PSC Box Beam and PSC Cored Slab Beam Bridges Common Item and Quantity Errors

Example 1 - PSC Box Beam Bridge

Example 2 PSC Cored Slab Beam Bridge

SECTION AT END BENT
SCALE: 3/16" = 1'-0"

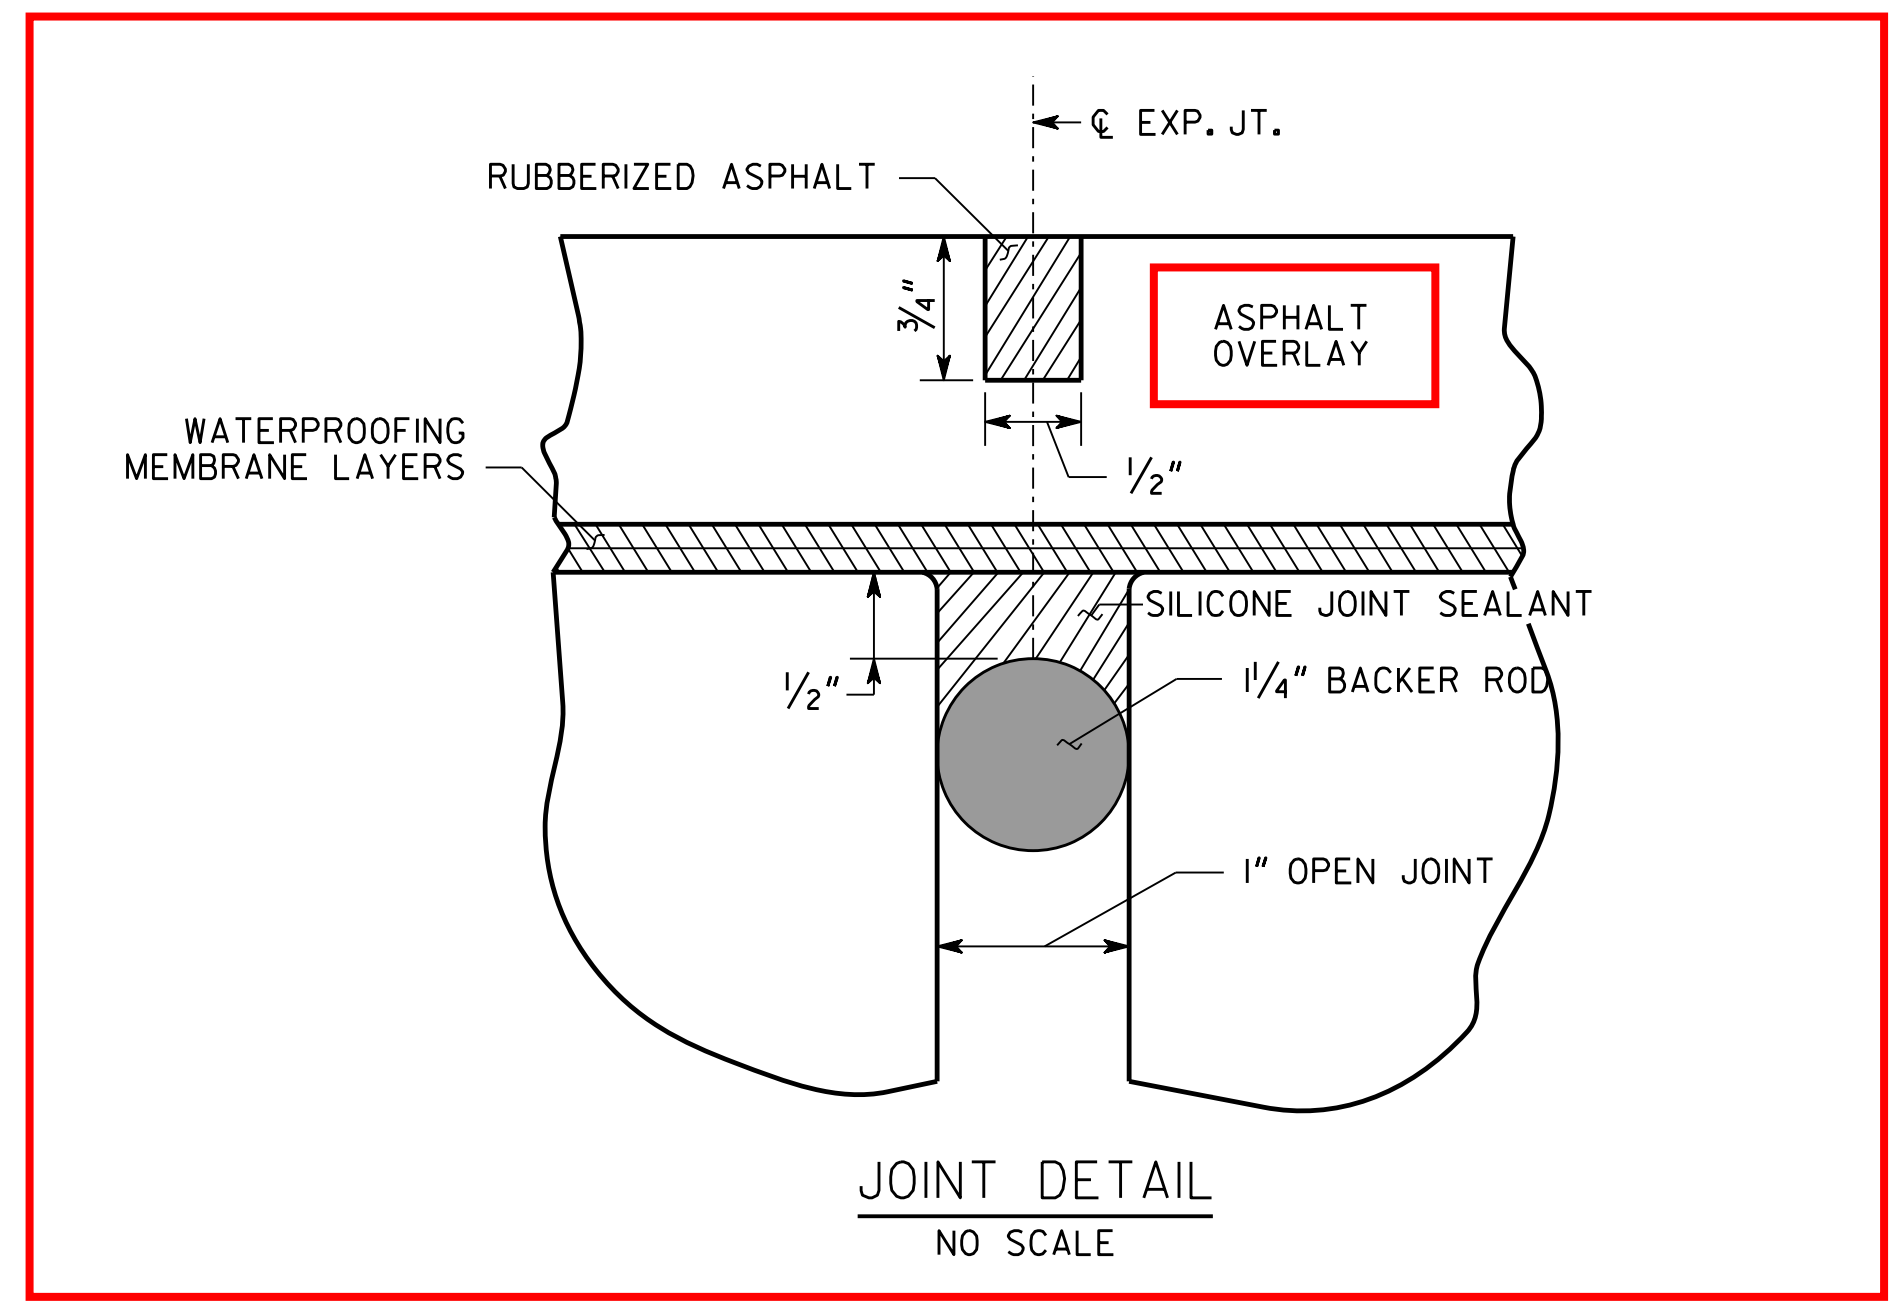
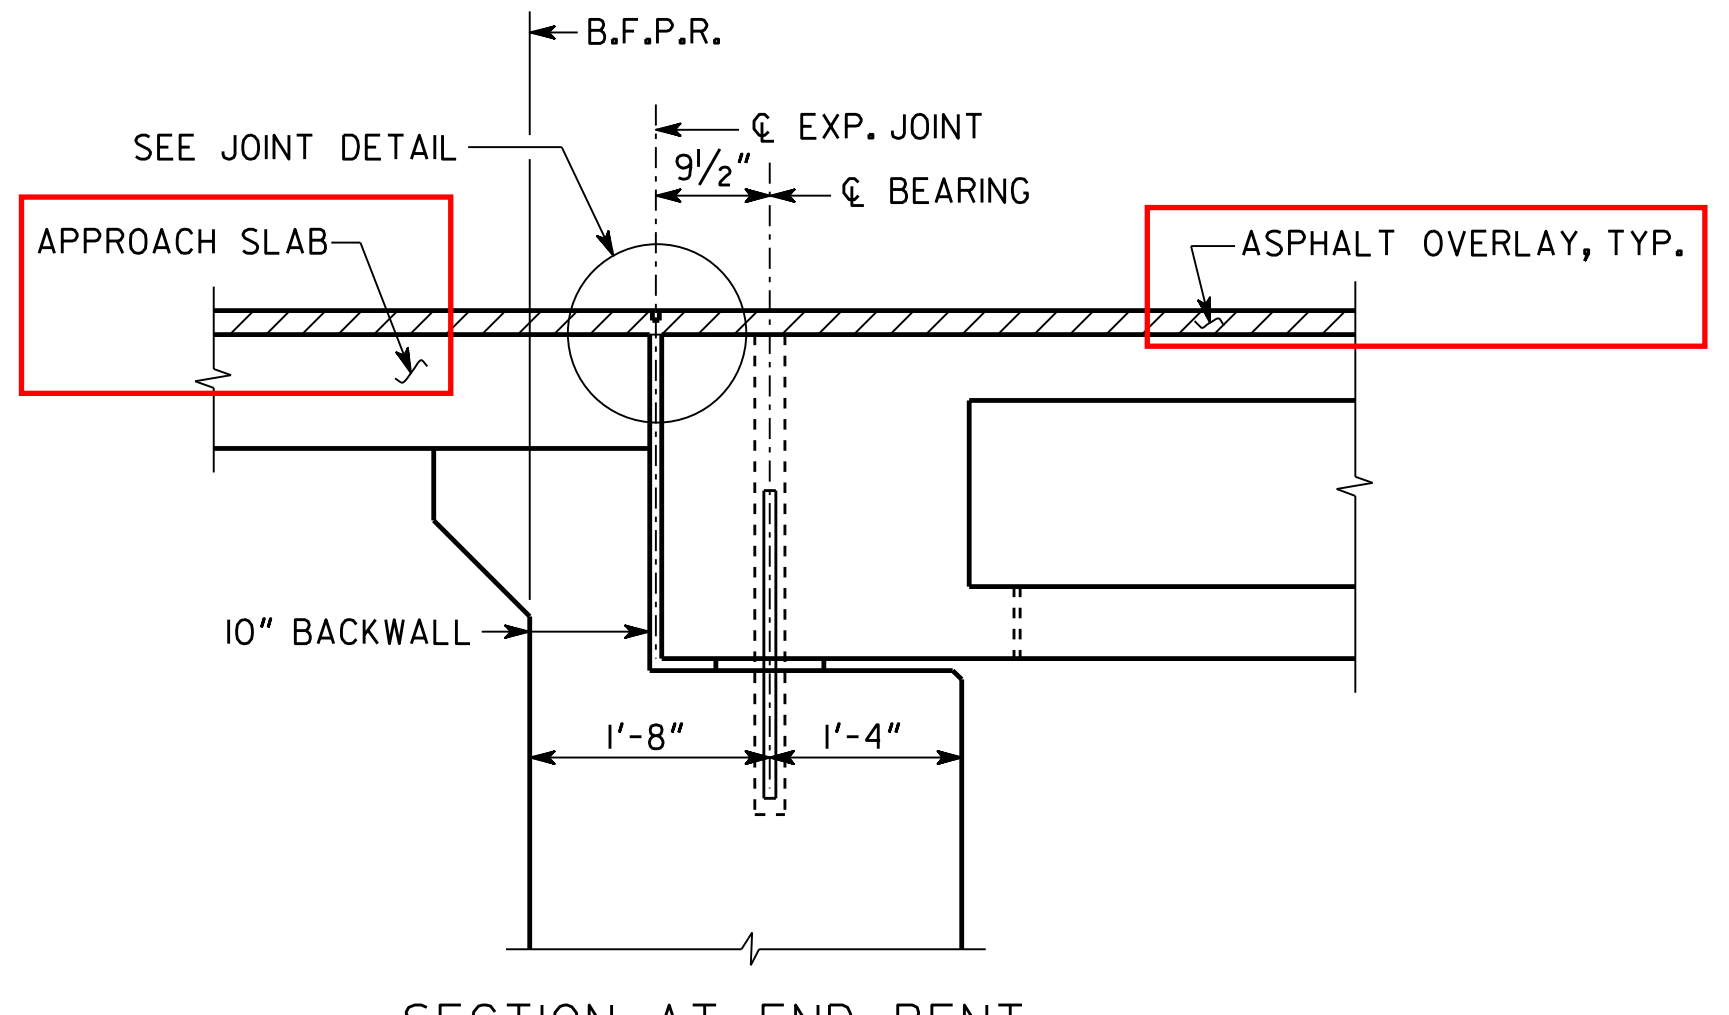
Review all the items outlined in red.
 Notice that the cross slope for this tangent alignment bridge is 2.0% (2.5% has been used on some projects). Since the bridge deck is leveled and overlaid the approach slabs are also leveled and overlaid. See the End Bent Joint Detail. Roadway cross sections way have to account for cross slope transition to meet the bridge cross slope.
 The Recycled Asphaltic Concrete Surface Course used on the bridge and approach slabs is the same as the roadway and should have the same spread rate. Typically this is either 135 LB/SY for 9.5 mm Superpve which is 1.25-inch thick or 165 LB/SY for 12.5 mm Superpave which is 1.5-inch thick. The preferred method is to use a 2-inch layer of 19 mm Superpave (220 LB/SY) between the Surface Course and leveling. In this case Leveling is used from the top surface of the Box Beams to the bottom of the 19 mm Superpave with the leveling creating the cross slope.

This project uses 9.5 mm Superpave thus after accounting for the 19 mm Superpave layer the leveling thickness using the minimum overlay thicknesses specified this 0.25-inch thick at the gutter line and 3.875-inch thick at the CL.

SECTION AT END BENT

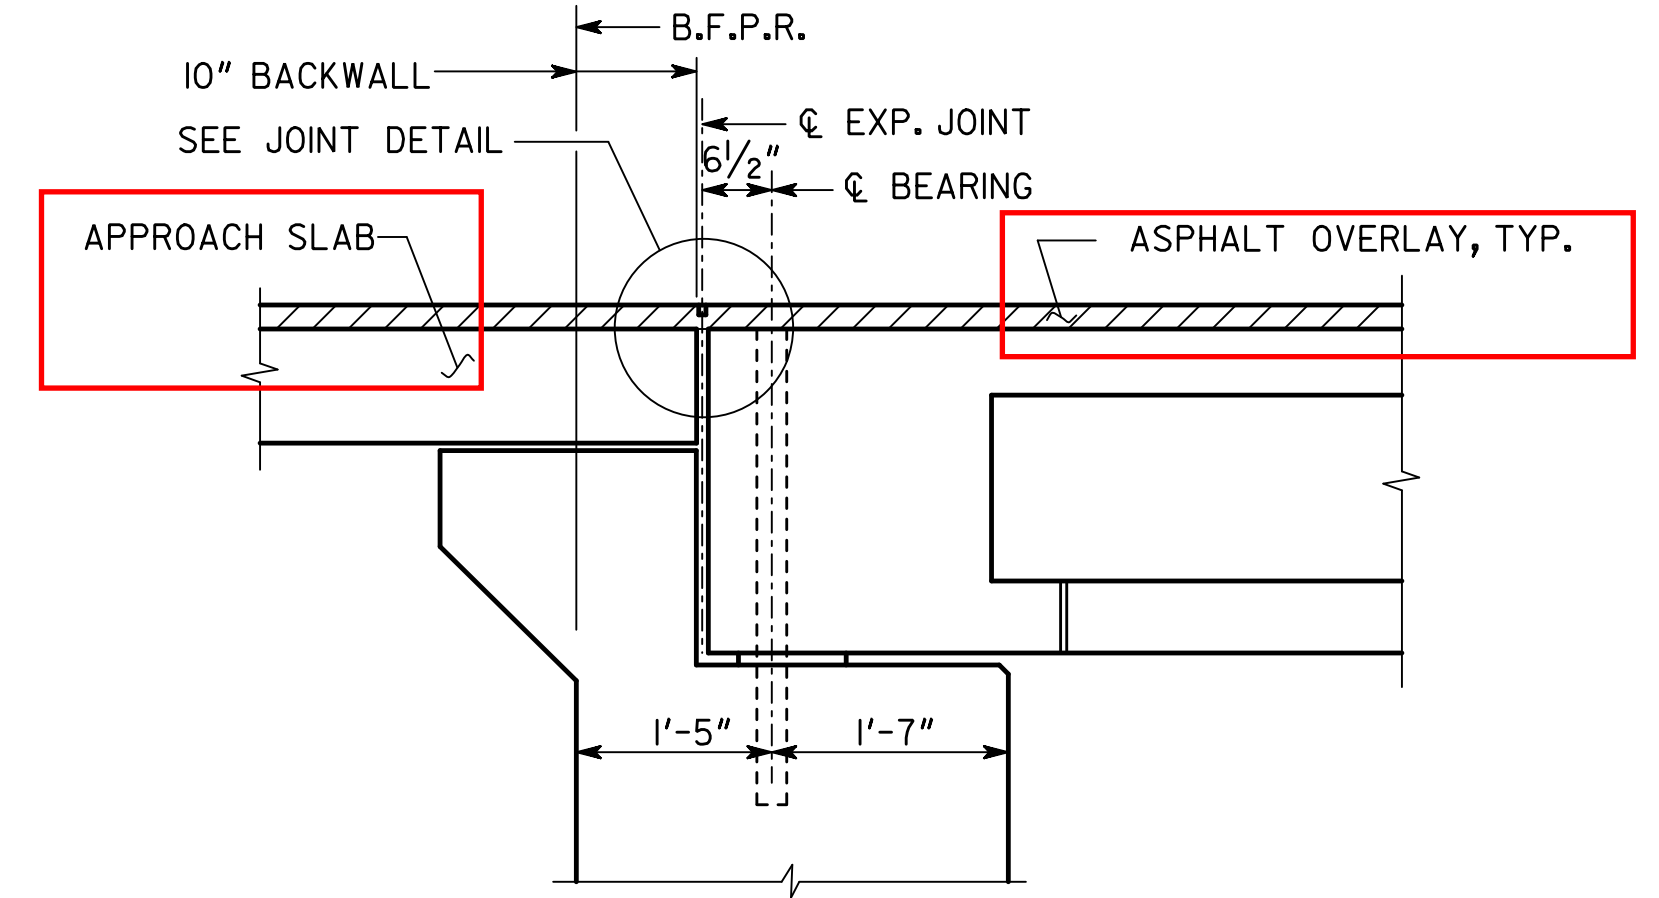
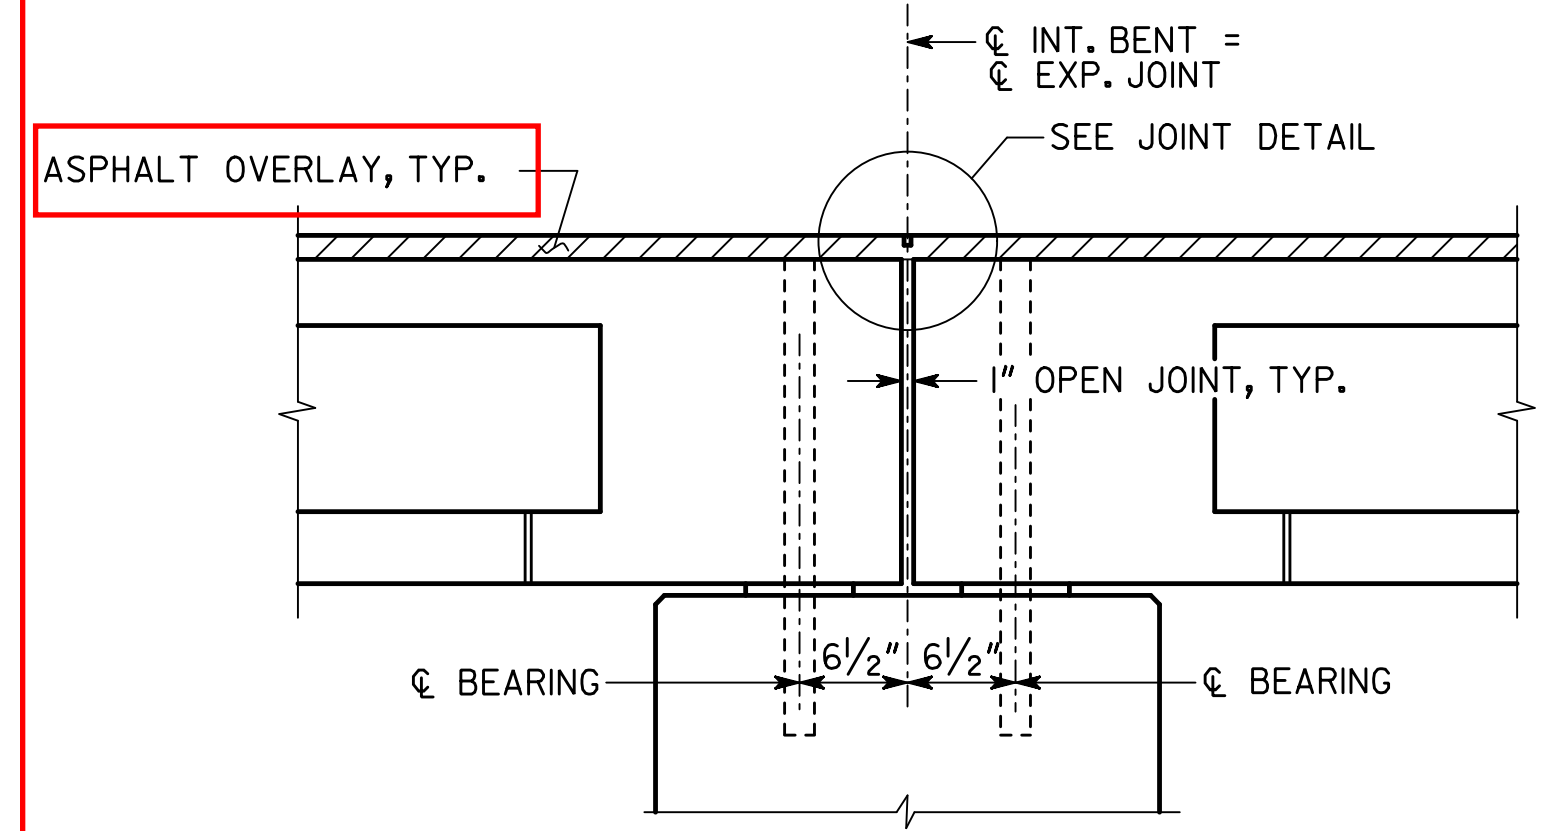
Review all the items outlined in red.
 Notice that the cross slope for this tangent alignment bridge is 2.0% (2.5% has been used on some projects).
 Since the bridge deck is leveled and overlaid the approach slabs are also leveled and overlaid. See the End Bent Joint Detail.
 Roadway cross sections may have to account for cross slope transition to meet the bridge cross slope.
 The Recycled Asphaltic Concrete Surface Course used on the bridge and approach slabs is the same as the roadway and should have the same spread rate. Typically this is either 135 LB/SY for 9.5 mm Superpave which is 1.25-inch thick or 165 LB/SY for 12.5 mm Superpave which is 1.5-inch thick. The preferred method is to use a 2-inch layer of 19 mm Superpave (220 LB/SY) between the Surface Course and leveling. In this case Leveling is used from the top surface of the Box Beams to the bottom of the 19 mm Superpave with the leveling creating the cross slope.

This project uses 9.5 mm Superpave thus after accounting for the 19 mm Superpave layer the leveling thickness using the minimum overlay thicknesses specified this 0.25-inch thick at the gutter line and 3.875-inch thick at the CL.
